RAI Volume 3, Chapter 2.2.1.4.2, First Set, Number 1:

RAI Volume 3, Chapter 2.2.1.4.2, First Set, Number 2:

RAI Volume 3, Chapter 2.2.1.4.2, First Set, Number 3:

Figure 1. Schematic Depiction of Borehole (map view) with a Bisecting Fracture

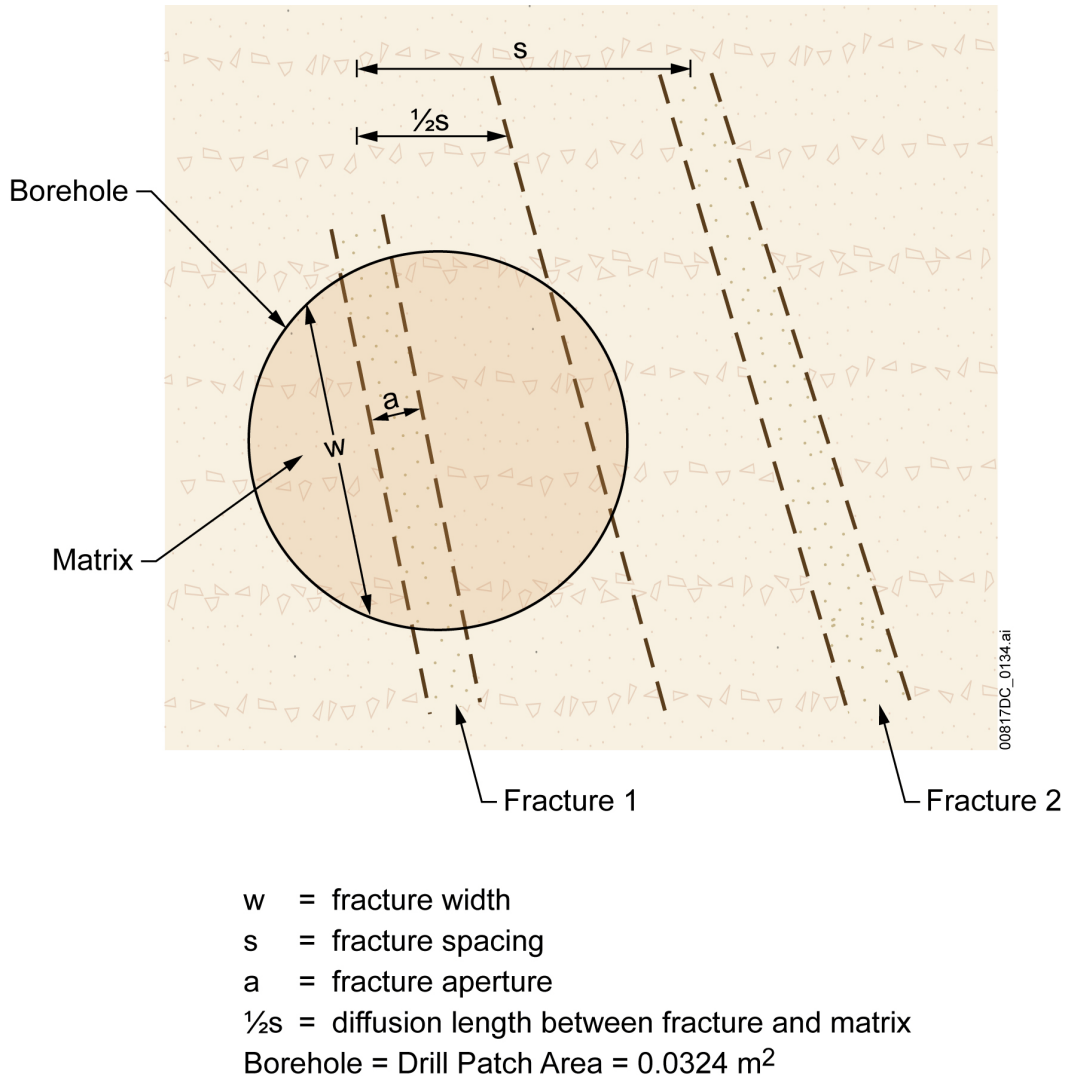
Clarify the technical basis for delay of radionuclide transport due to matrix diffusion in the borehole.

Basis: Advective flow of water in the borehole potentially results in very short travel times (e.g., on the order of a few years) in the borehole when fracture-matrix interactions are ignored (see section 2.4.3.3.5.1 of the SAR, page 2.4-316). The SAR suggests that sorbing radionuclides are delayed significantly due to matrix diffusion (Figure 2.4-170). But the supporting information does not clearly explain the basis for how the relatively slow matrix diffusion process has such a significant effect given the very short travel times and the limited time over which the matrix diffusion process can occur. The staff needs this information to determine compliance with 10 CFR Part 63.114.

In the TSPA model, radionuclide transport through the borehole is modeled using the GoldSim pipe pathway element. The conceptual model of the borehole is depicted in Figure 6.7-6 of *Total System Performance Assessment Model/Analysis for the License Application* (SNL 2008), which is reproduced as Figure 1. Vertical transport down the unsaturated fracture is represented as two parallel plates with no infill between the plates. The distance between the plates is the average fracture aperture for the rock units comprising the devitrified tuff of the repository horizon, which includes the host-rock units TSw34, TSw35, and TSw36, with the width of the plates determined by the size of the borehole. Molecular diffusion occurs between the fracture and borehole rubble surrounding the fracture, and then through the porous medium. Radionuclide decay and decay product growth occur in both the fracture and the matrix. Although no sorption is modeled in the fractures for any radionuclide, sorption is modeled in the matrix. Consistent with the treatment in the three-dimensional unsaturated zone transport model, the partition coefficients for sorption in the matrix are those for devitrified tuff. The input parameters for the borehole transport model are defined in Table 1.

The conceptualized human intrusion borehole is an 8-inch diameter borehole that extends 190 m from the bottom of the waste package to the highest expected water table elevation. The borehole is modeled with a rectangular fracture area equal to the product of the unsaturated zone fracture aperture and the average width of the unsaturated zone fracture. The average width of the fracture is calculated by dividing the borehole cross-sectional area by its diameter. The fracture pathway has an average saturation of 0.0234, but the saturation varies by percolation subregion and infiltration case. This average value is the weighted average of the fracture saturation applied in the unsaturated zone transport model. Saturation values for each infiltration case and percolation subregion are weighted by a factor that accounts for the probability of each infiltration case and the probability of the human intrusion intersecting each percolation subregion. The reference fluid in the fracture pathway is water and imposes no solubility limits.

Figure 1. Schematic Showing the Conceptualized Flow Processes near Perched Water Zones within a Typical West-East Cross Section of the Site-Scale Unsaturated Zone Flow Model Domain

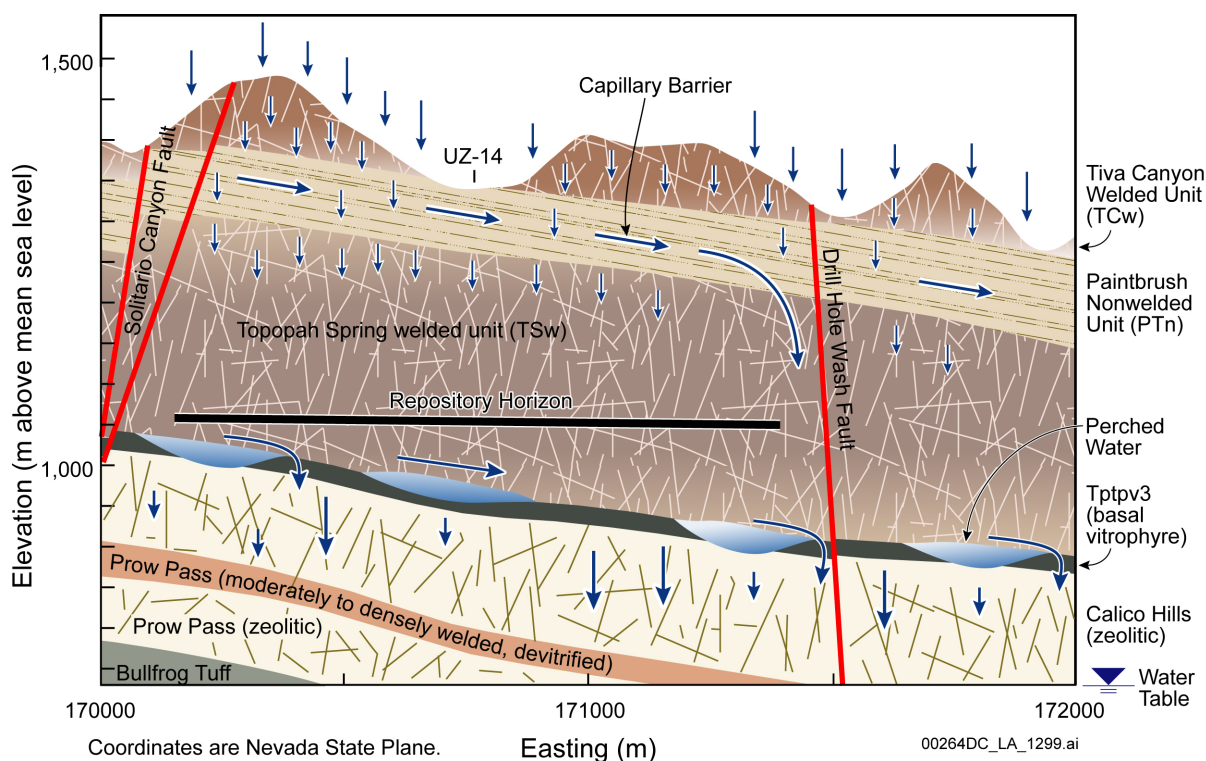
Address the impact on overall performance of drilling through the perched water below the repository to the saturated zone, considering the volume and areal extent of the perched water and the potential effect on the transport of radionuclides within the unsaturated zone.

Basis: DOE has included perched water in its TSPA as a feature that deflects radionuclide transport paths laterally to faults, then down to the saturated zone. The human intrusion scenario (i.e., borehole to the saturated zone) could result in a borehole penetrating the perched zone and thereby potentially affecting the pathway of radionuclides within the perched zone down to the saturated zone (i.e., radionuclides released from breached waste packages, which are transported to a perched zone, could subsequently enter the borehole and move down the borehole to the saturated zone). The staff needs this information to determine compliance with 10 CFR Part 63.322.

Perched water in the Yucca Mountain region tends to occur when units with well-connected fracture porosity, such as in the Topopah Spring welded unit (TSw), overlie low-permeability or poorly fractured units such as the basal vitrophyre of the lower TSw, or the hydrothermally altered zeolitic Calico Hills unit (CHn). Figure 1 (SAR Figure 2.3.2-5) shows a cross section of these hydrogeologic units and a conceptualization of flow patterns near perched water bodies, indicating lateral fracture flow in the TSw above the perched zones. Although flow does occur through the fractures of the areally extensive basal vitrophyre, it is limited because the fractures are frequently filled with alteration products that tend to block flow .

Just below the repository but above the perched water, the gently eastward dipping TSw has low porosity and widespread fracturing typical of densely welded tuffs, which results in fracture-dominated advective-dispersive transport (Figure 1). The strongly altered northern part of the CHn unit, composed of zeolites and clays with low permeability and poorly developed, sparsely connected fractures, results in a low permeability layer. Because of the low permeability, water flux to the CHn unit and just above the perched zone may be diverted laterally, down-dip to the east towards the faults, which act as main pathways for fast flow and transport in the unsaturated zone. A human intrusion borehole through the perched zone may act as a high permeability fast
